HISTORIC AND DESIGN REVIEW COMMISSION

August 17, 2016

Agenda Item No: 10

HDRC CASE NO: 2016-320
COMMON NAME: 100 N MAIN
LEGAL DESCRIPTION: NCB 909 BLK LOT A8 & A 9
ZONING: D S H HE RIO-3
CITY COUNCIL DIST.: 1
DISTRICT: Main/Military Plaza Historic District
LANDMARK: Bell Furniture / Wolfson's
APPLICANT: Randy Kelly/JRK Design
OWNER: REM Hospitality
TYPE OF WORK: Conceptual approval of new construction of a mixed use tower
REQUEST:

sheet description
 Exterior
 Elevations

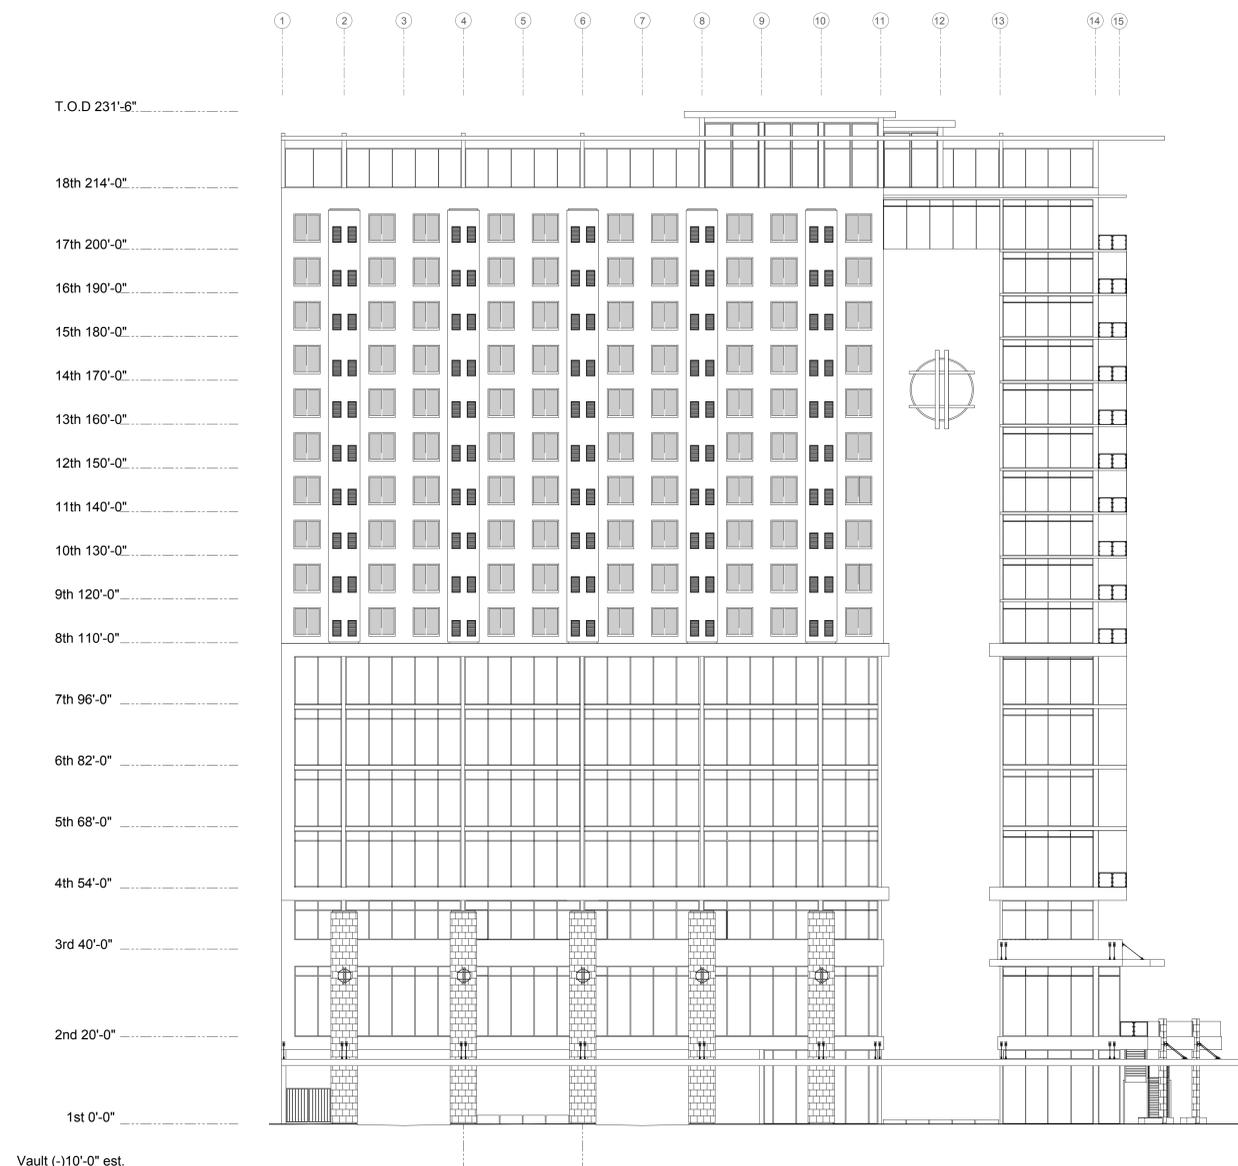
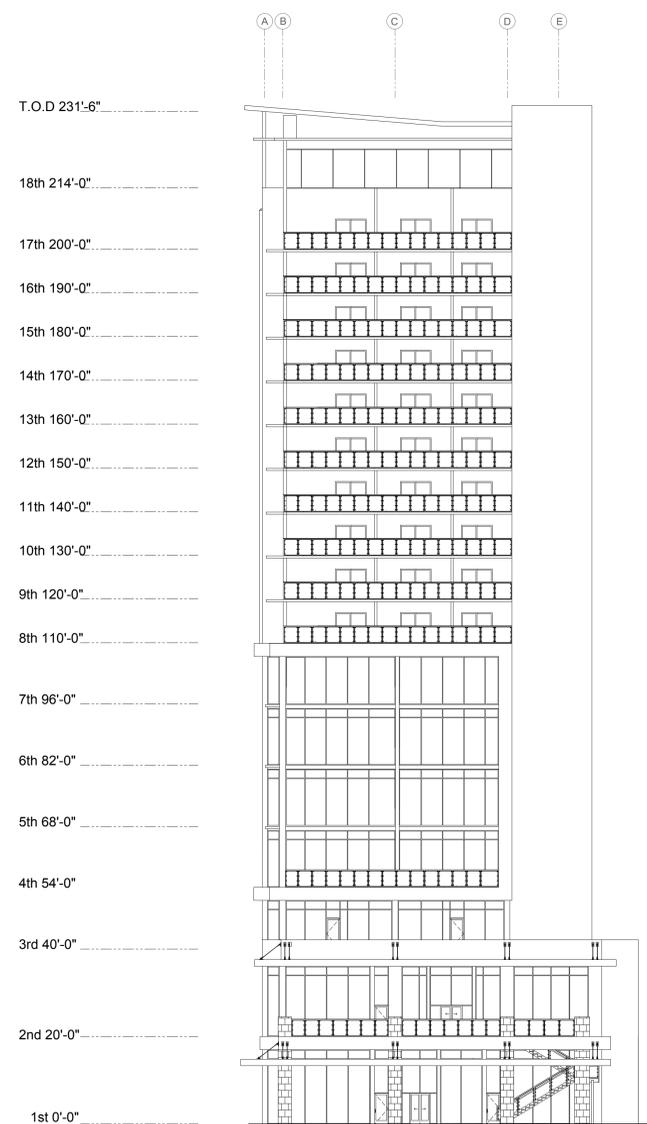
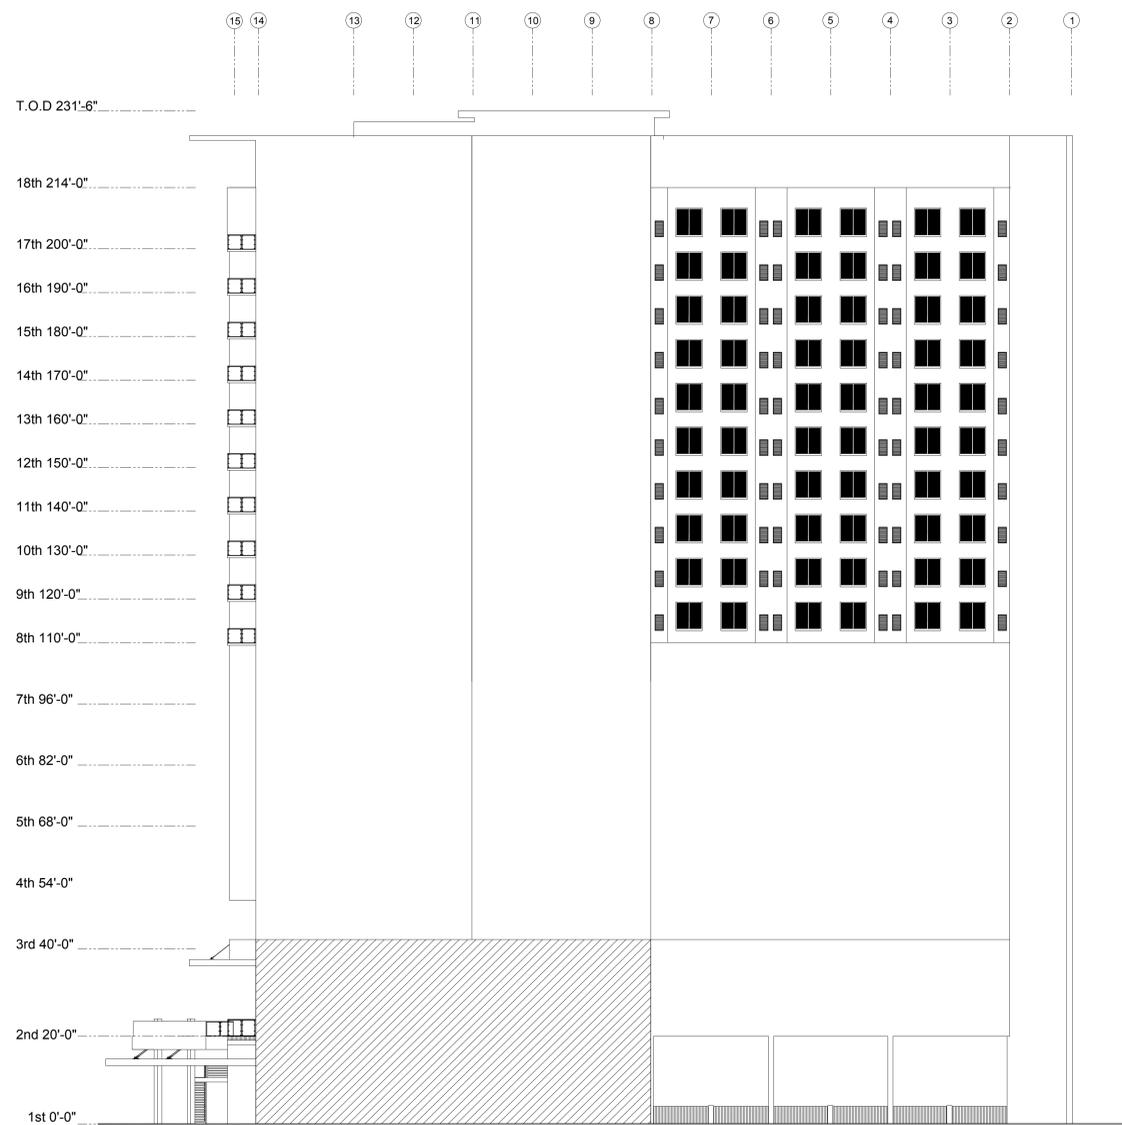
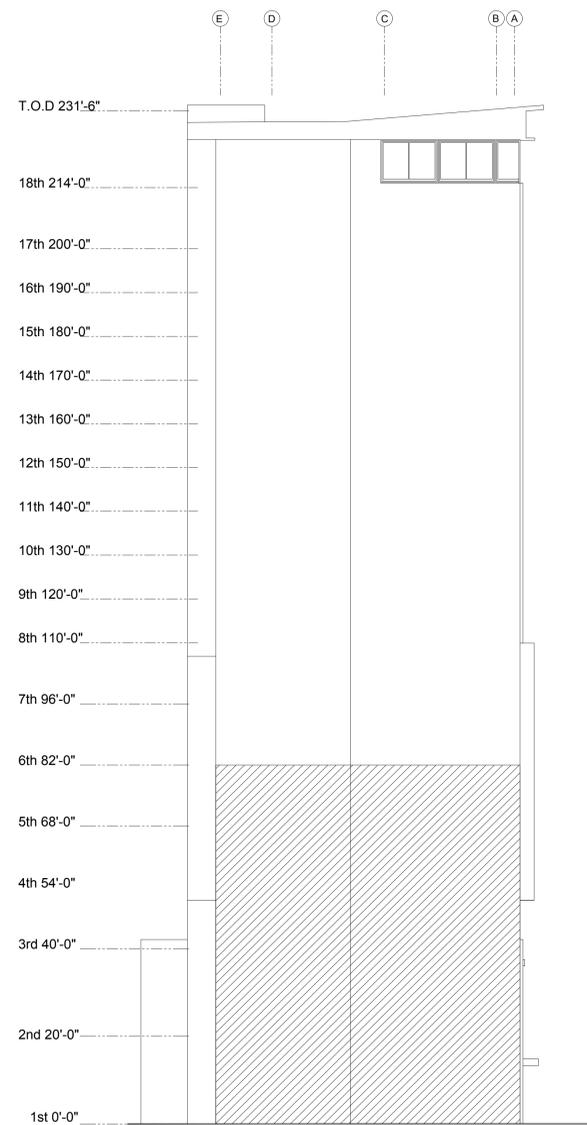
- q. **FAÇADE COMPOSITION** – The proposed new construction features an elevation that is adjacent to Riverview Tower that does not feature window fenestration on sections of the façade that are in immediate proximity to Riverview Tower. As the tower separates itself from Riverview Tower, fenestration is added to the façade. Staff finds this appropriate. The north (project west) elevation currently features no fenestration. The Riverview Tower parking structure is immediately adjacent to this façade; however above the roof of the parking structure, staff finds that addition façade separation elements and fenestration should be added. If the applicant elects not to include fenestration at this elevation, staff finds that a public art display which could include a lighting element should be used.

- r. **WINDOWS** – The UDC Section 35-674(e)(2) provides information in regards to proper window fenestration and installation. For window openings that are not included within a curtain wall system, an inset of at least two to three inches within each wall is required. The applicant is responsible for complying with this section of the UDC.

- i. That the applicant provide a complete landscaping plan noting all paving and plant materials.
- ii. That the applicant provide additional information regarding proposed façade materials including dimensions of proposed panels and curtain wall systems.
- iii. That the applicant inset each window into walls at least two to three inches.
- iv. That the applicant introduce fenestration to the north facing façade or introduce a public art element as noted in finding q.
- v. Archaeological investigations may be required. The development project shall comply with all federal, state, and local laws, rules, and regulations regarding archaeology.
